5596XL LCD Ground Strap Retrofit

Retrofit for 5596XL to prevent a static discharge from blanking out the LCD display.

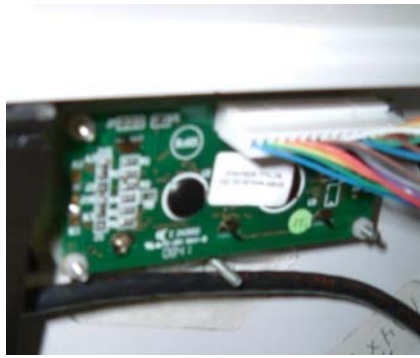
Issue: There have been reports from customers with the 5596XL vending unit about them going into sleep mode and how to prevent that from happening. Customers have had to unplug and plug back in the unit to get it to come out of this sleep mode. The 5596XL unit does not have a sleep mode. It has been determined that a static discharge (electric shock) from a person touching the coin return, coin box, or key lock can blank out the LCD display. Sometimes a row of black boxes appears across the first line of the LCD display

Resolution: A ground strap is being added between the LCD display module and the 5596XL chassis.

1. Open up the 5596 coin box
2. Locate the ground wire provided in this retrofit package
3. Remove the nut holding the ground strap between the door and the chassis

4. Place one end of the LCD ground wire over the stud
5. Replace the nut holding, holding both ground wires

6. Locate the LCD module in the coin box

7. Remove one of the nuts holding the LCD module in place
8. Place the other end of the LCD ground wire over the stud
9. Replace the nut holding the ground wire to the LCD module
